VALUE ENGINEERING STUDY

Project # CSSTP-0006-00(252) PI No. 0006252
Project # CSSTP-0006-00(253) PI No. 0006253

**S.R. 44 from US 441 to I-20
Putnam/Greene County, Georgia**

6 December 2012

PROPOSAL NUMBER: R3-5

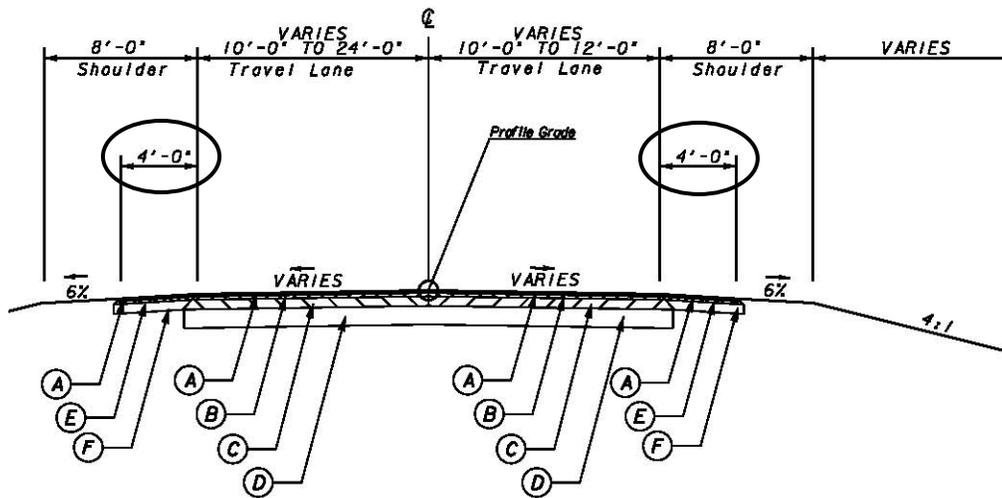
PROPOSED CHANGE: It is proposed to eliminate the paved shoulders on the rural side street sections.

Proposed Change: Eliminate paved shoulders

PROPOSAL NUMBER: R3-7

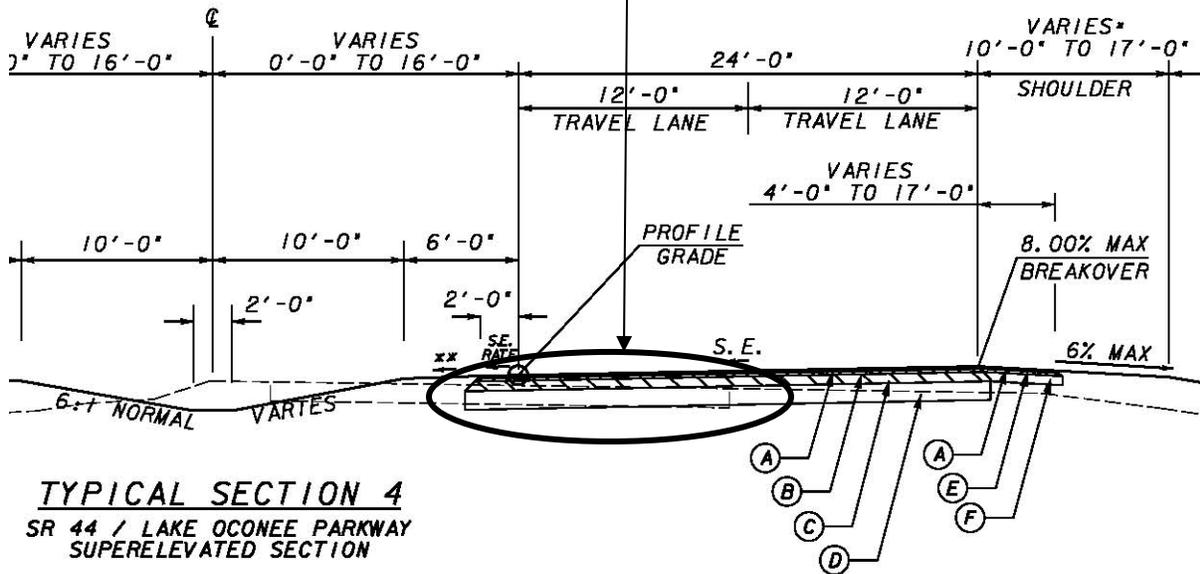
PROPOSED CHANGE: It is proposed to utilize the existing pavement in lieu of full depth pavement from Sta 900+00 to Sta 966+00, from Sta 974+00 to Sta 982+00, from Sta 1155+00 to Sta 1183+00, and from Sta 1186+00 to Sta 1191+00.

JUSTIFICATION: An existing pavement evaluation has not been completed, but based on photo evidence the existing pavement appears usable. The profile for SR44 can be revised to closer match the existing and will meet the required 55 mph design speed in the rural section, 45 mph design speed in the urban section and will meet the requirements of GDOT and AASHTO.

Proposed Change: Overlay where possible in lieu of full pavement section

PROPOSAL NUMBER: R3-8

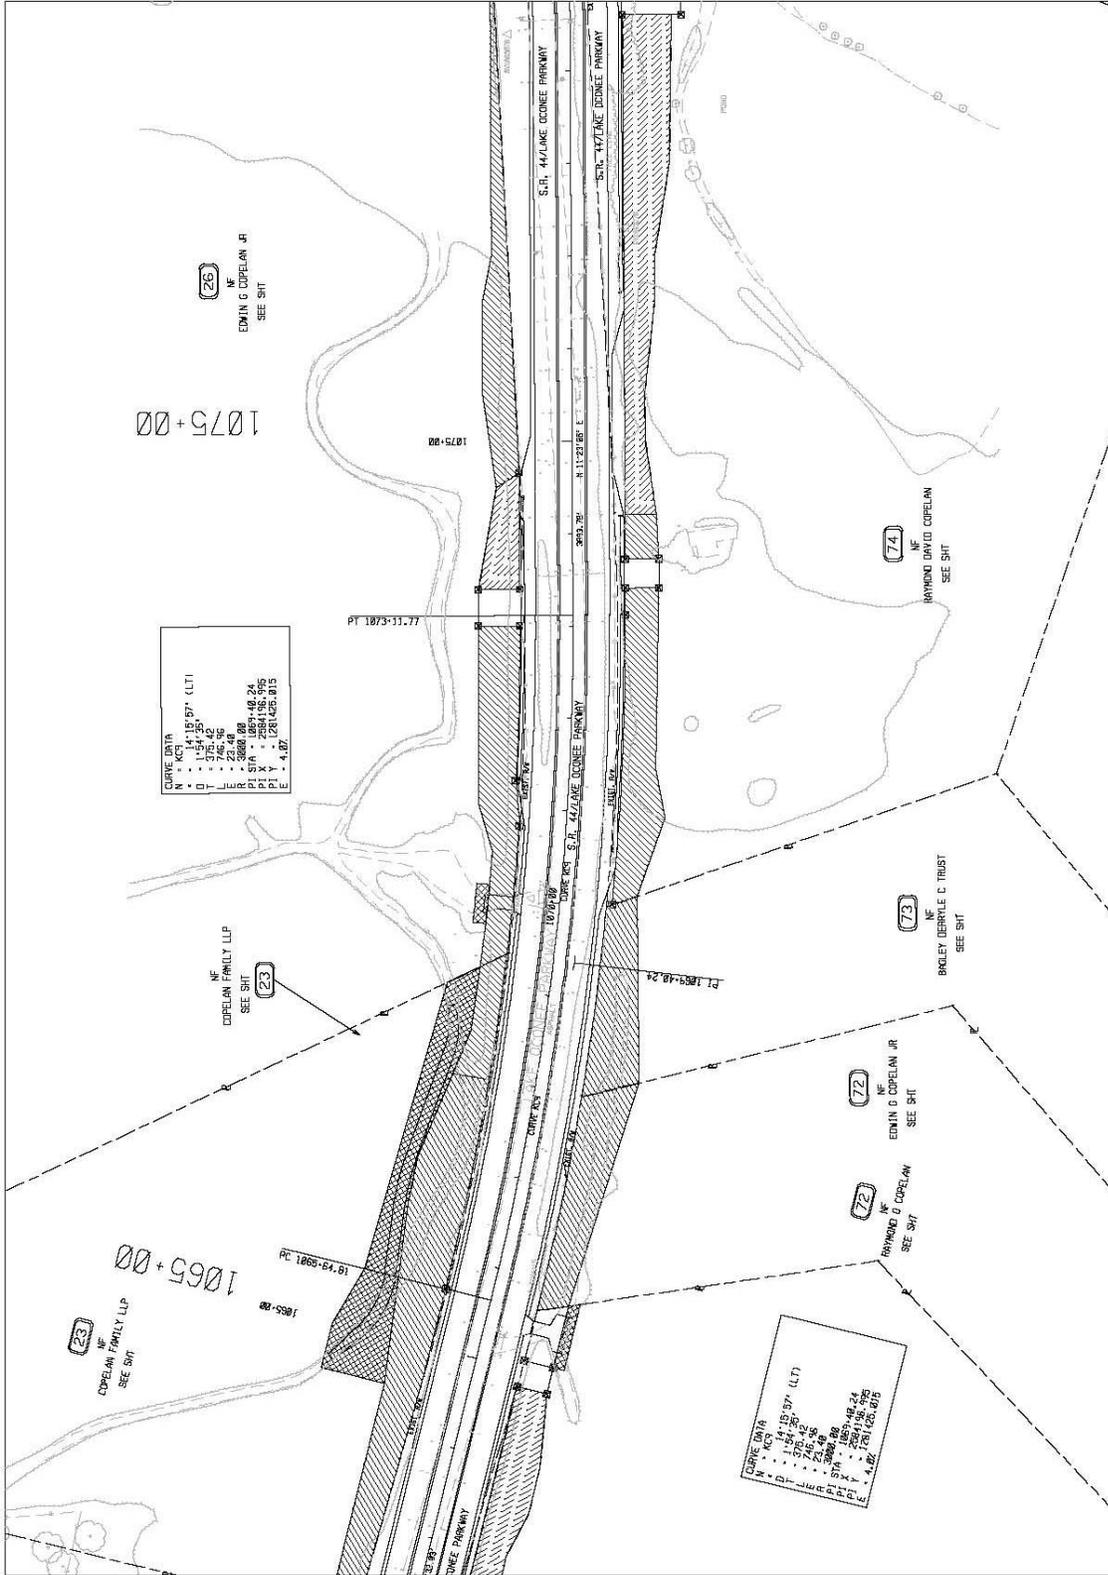
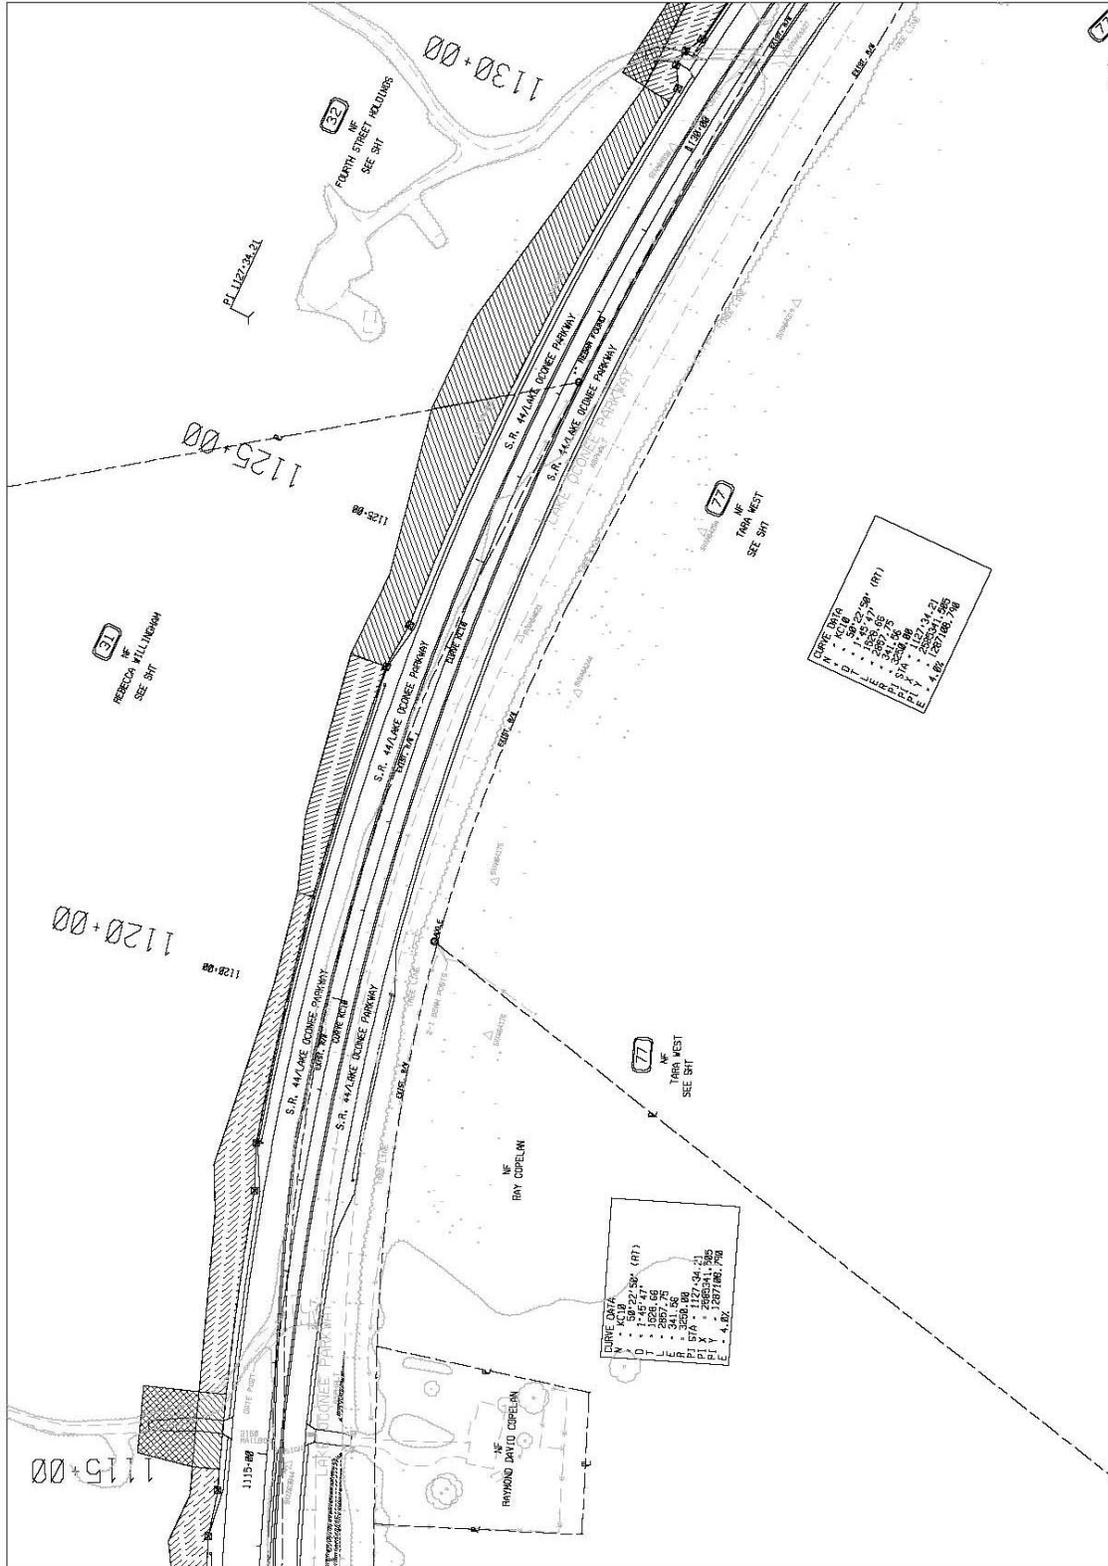
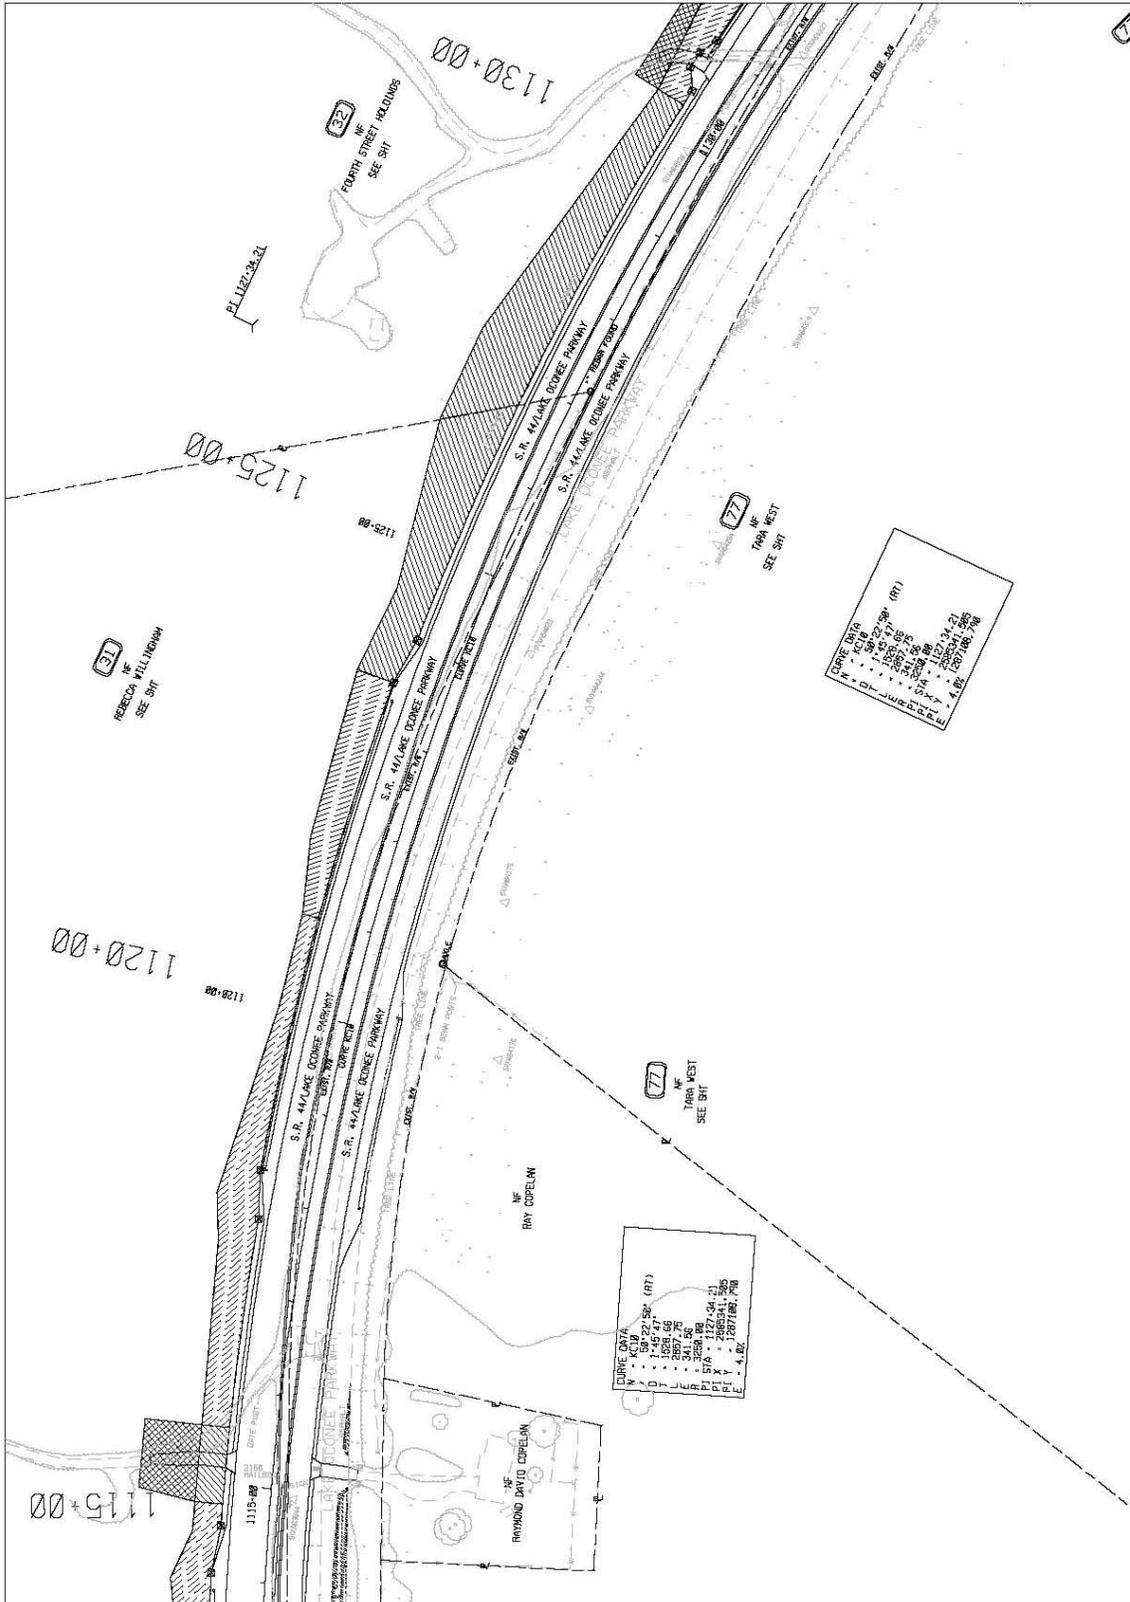
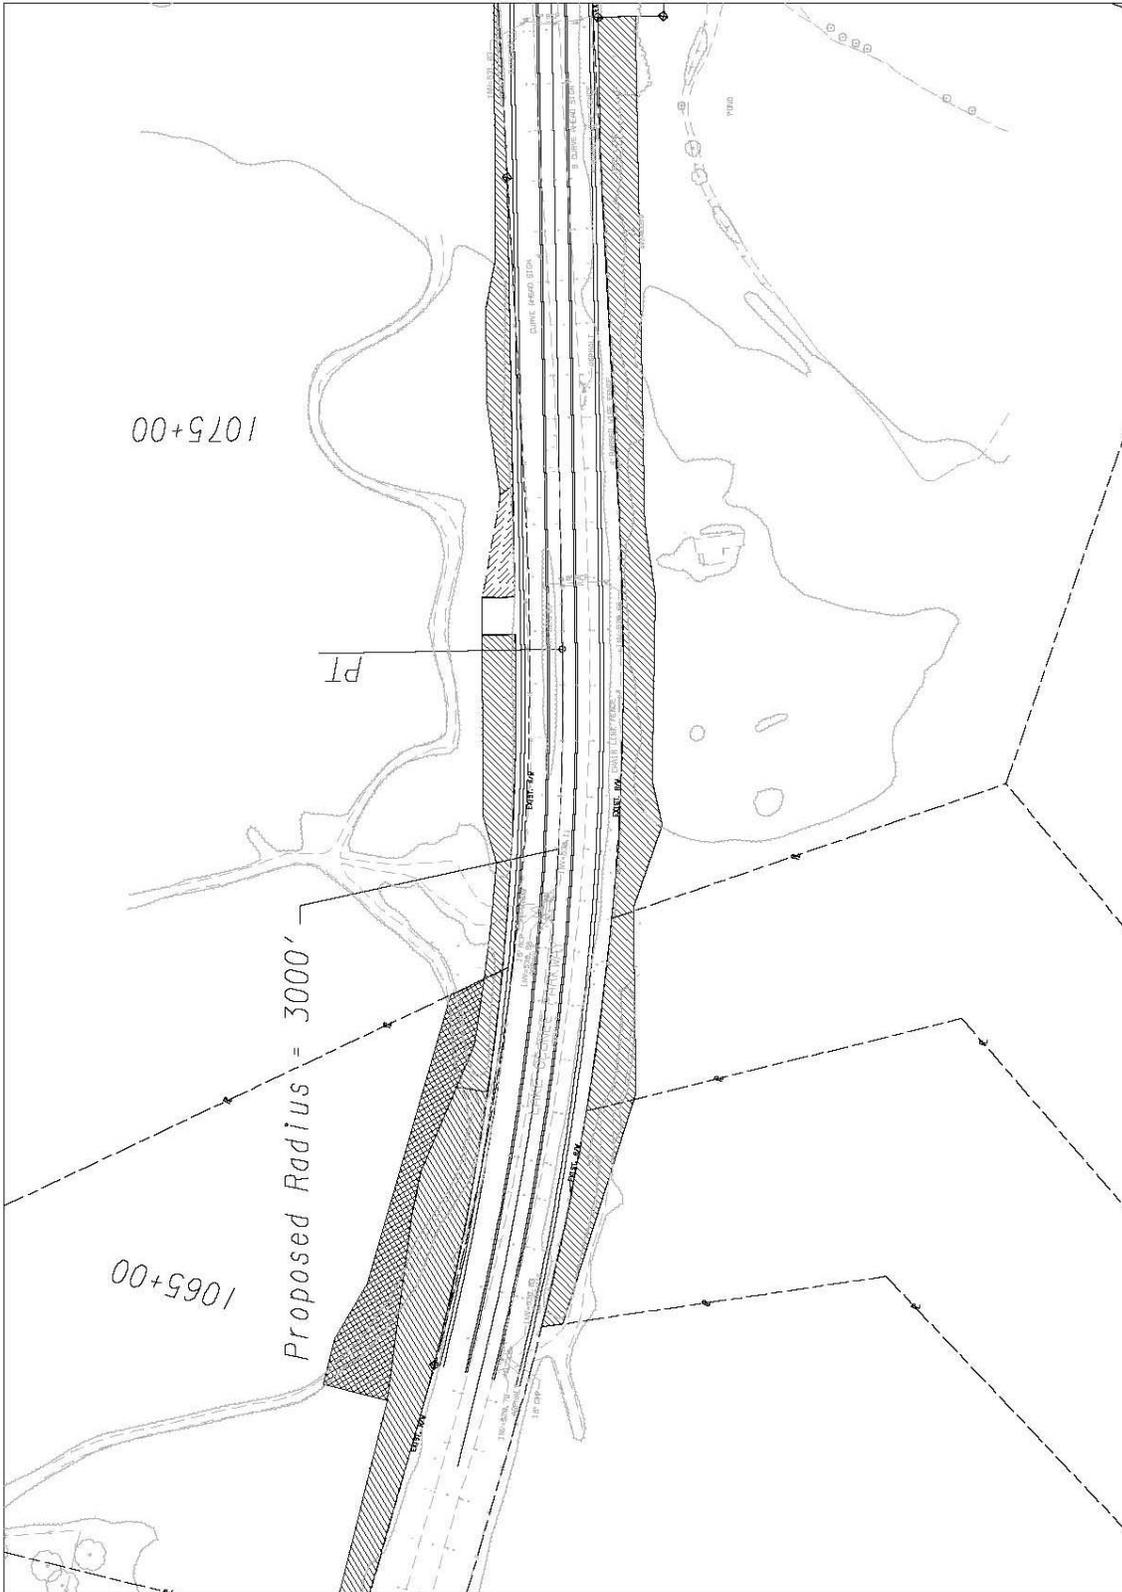
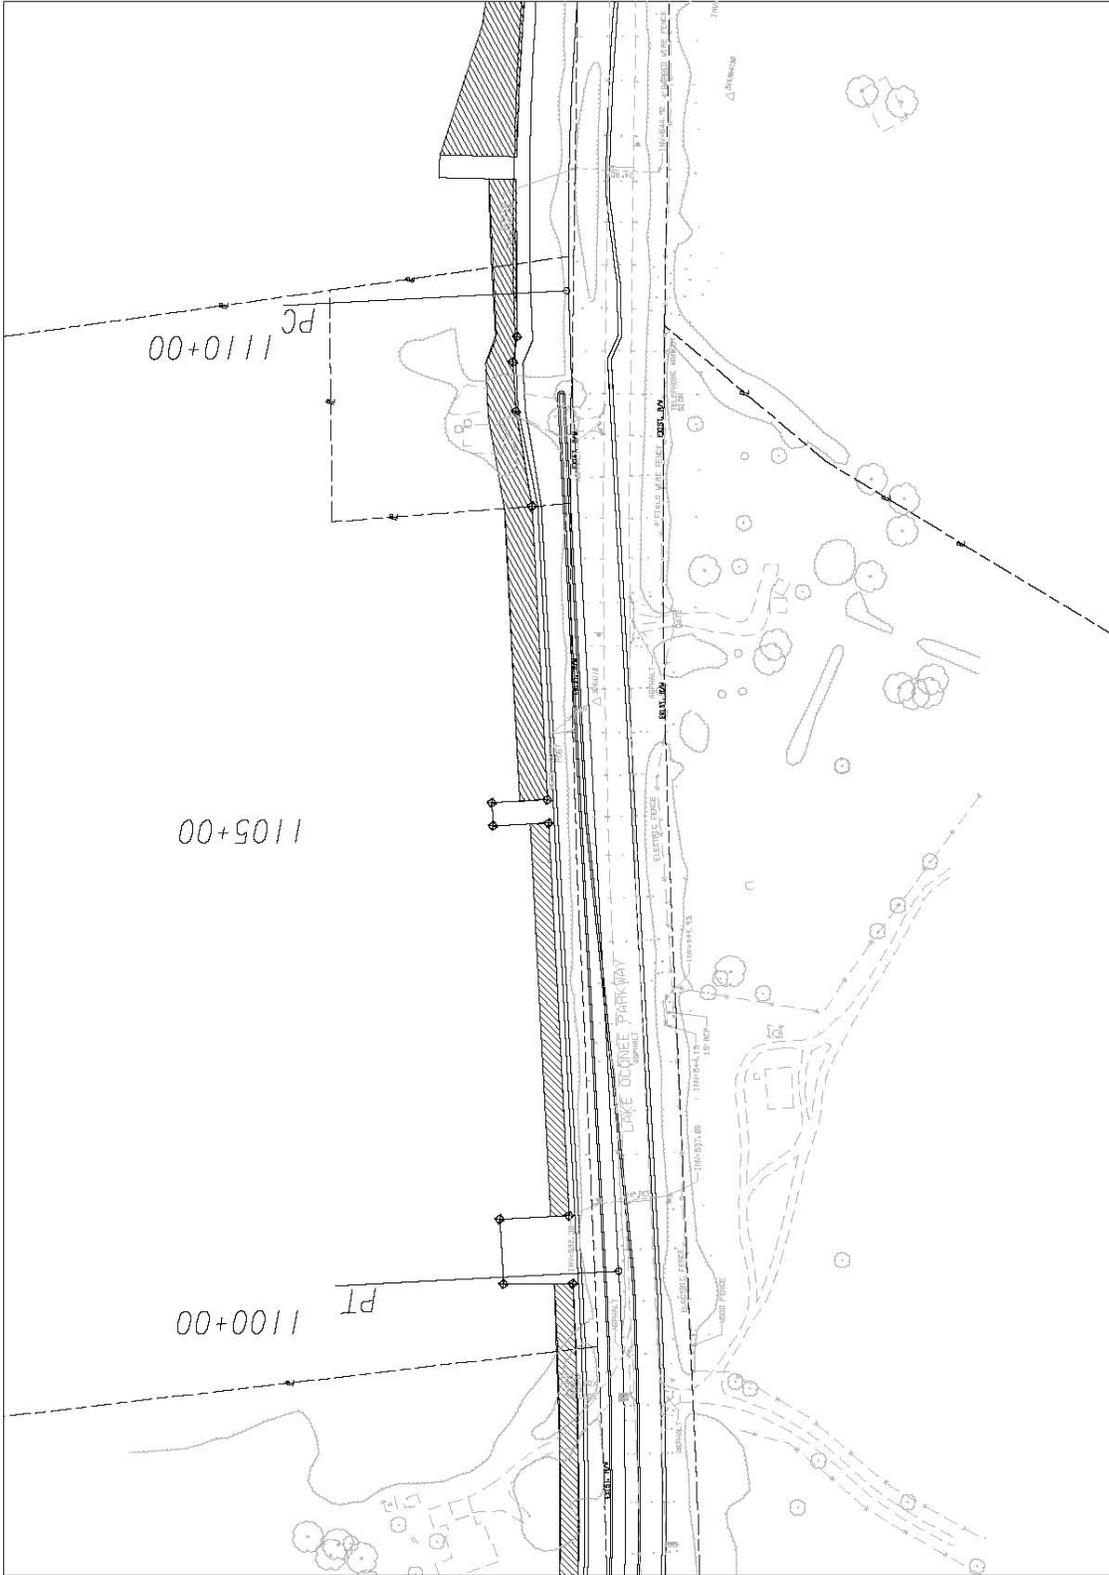
PROPOSED CHANGE: It is proposed to shift the horizontal alignment of SR44 to more closely follow the existing curved alignment and avoid impact to the lake located at Sta 1093+00 and avoid taking the house on Parcel 34 at Sta 1135+00.

JUSTIFICATION: The alignment of SR44 can be revised to closer match the existing and will meet the required 55 mph speed design in the rural section and will meet the requirements of GDOT and AASHTO.
